HISTORIC AND DESIGN REVIEW COMMISSION

HDRC CASE NO: 2022-361
ADDRESS: 1127 NOLAN ST
LEGAL DESCRIPTION: NCB 1665 BLK 1 LOT C
ZONING: R-6, H
CITY COUNCIL DIST.: 2
HIST. DIST. NAME: Dignowity Hill
APPLICANT: Garrett Cox/1127 NOLAN ST
OWNER: Garrett Cox/1127 NOLAN ST
TYPE OF WORK: Partial demolition, addition
APPLICATION RECEIVED: June 7, 2022
60-DAY REVIEW: Not applicable due to City Council Emergency Orders
CASE MANAGER: Jessica Anderson

The applicant requests a Certificate of Appropriateness for approval to demolish a small water heater closet and construct a 28'x16' rear addition.

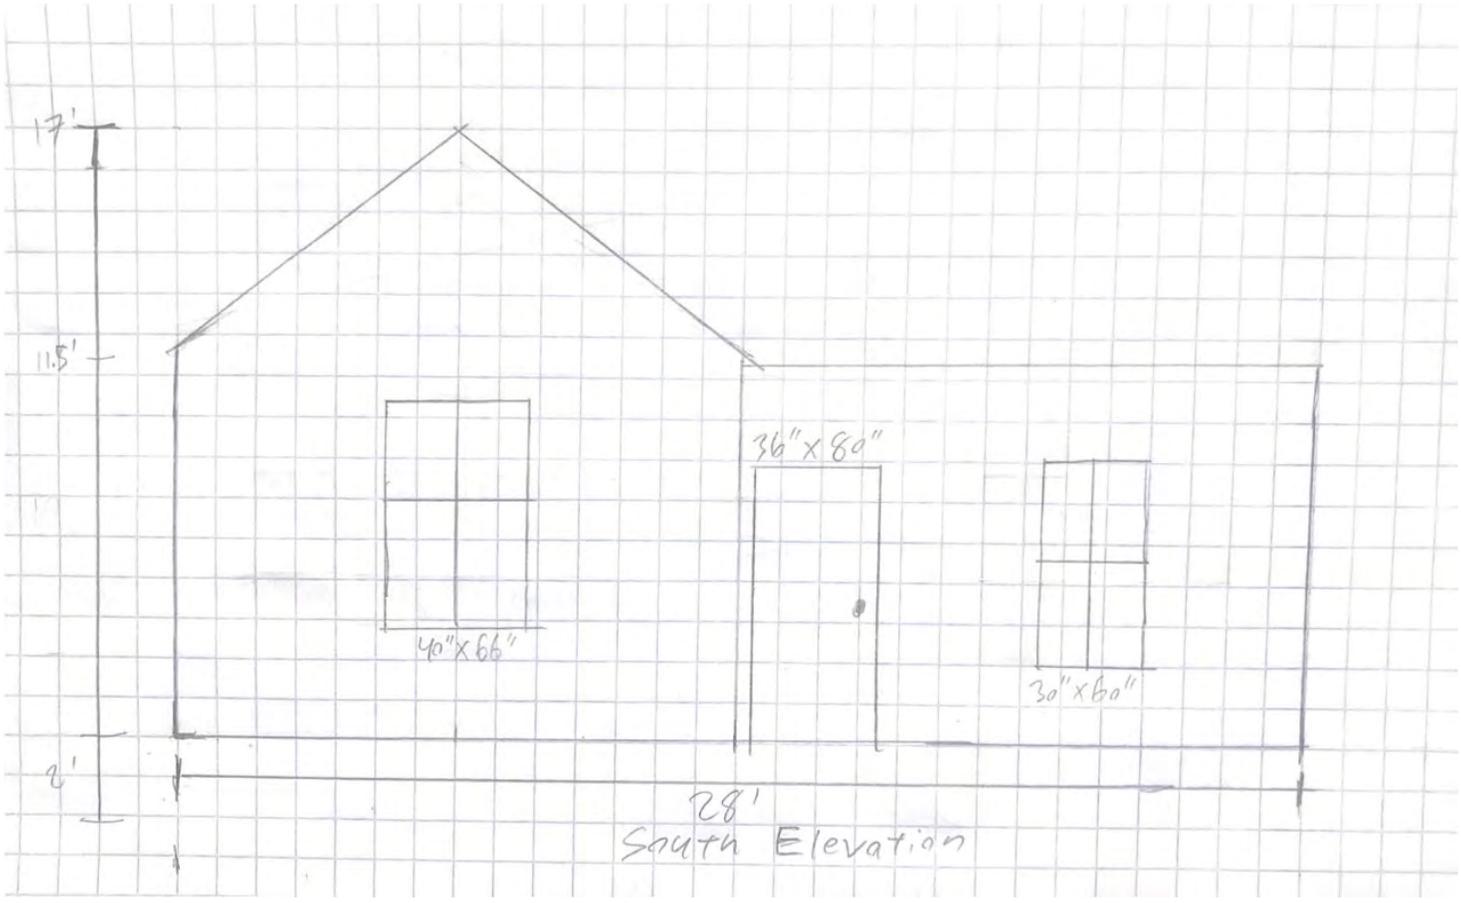
- d. **REAR ADDITION:** The applicant requests approval to construct a one-story addition to the rear of the property. Staff finds the proposed addition generally appropriate.

Back of House
North Elevation

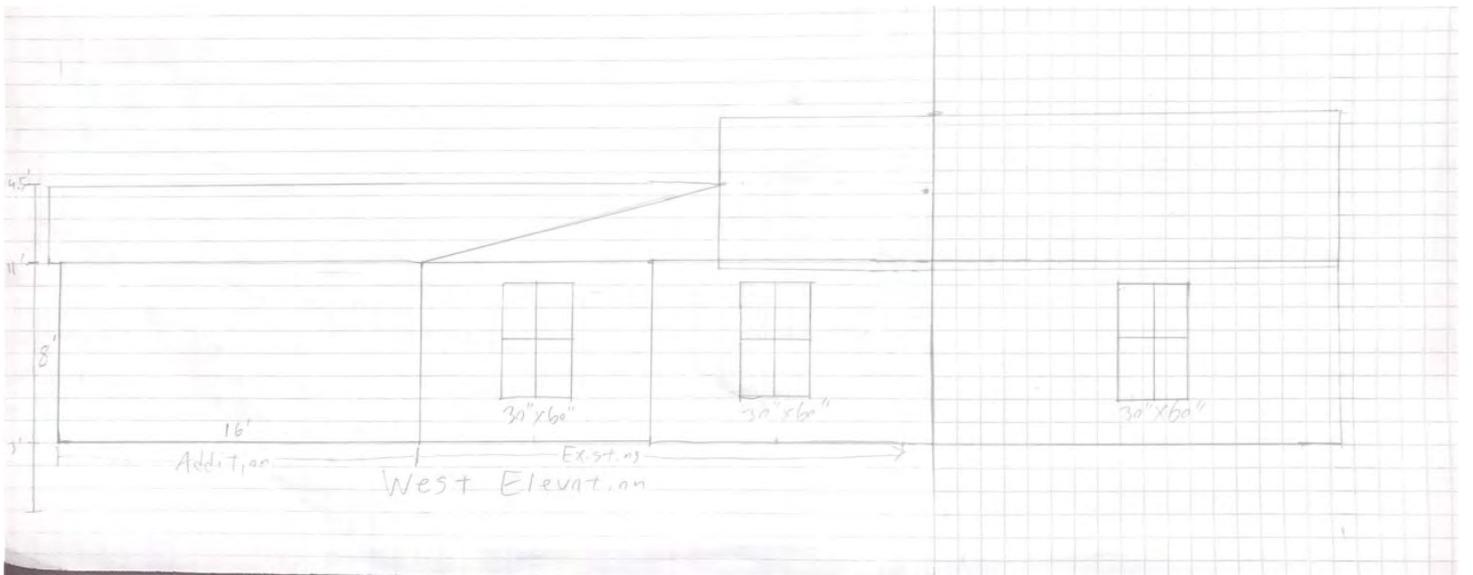
- f. **WINDOWS (ADDITION):** The applicant proposes to include two 24"x60" wood windows, one 24"x36" wood window, and three ganged 30"x60" windows on the north elevation of the proposed addition and one 30"x60" window on the west elevation to match existing wood windows on that elevation. The applicant shared with staff that he plans to find salvaged wood windows for the project. Staff finds the use of salvaged wood windows appropriate, but recommends windows that are 60" tall all be 30" wide to match conditions on the existing addition. Staff finds the 24"x36" wood window on the north elevation generally appropriate. All windows, regardless of size, should be one-over-one and wood sash.

- i. That the existing east window on the c. 1966 addition remain.
- ii. That one-over-one wood sash windows on the north elevation measuring 60" in height be 30" in width to match existing conditions.
- iii. That the applicant propose an appropriate style of door for the east elevation of the proposed addition.
- iv. That wood siding on the proposed addition match the 1909 phase of construction in profile and dimensions.
- v. That the applicant submit more detailed construction documents prior to release of the COA.
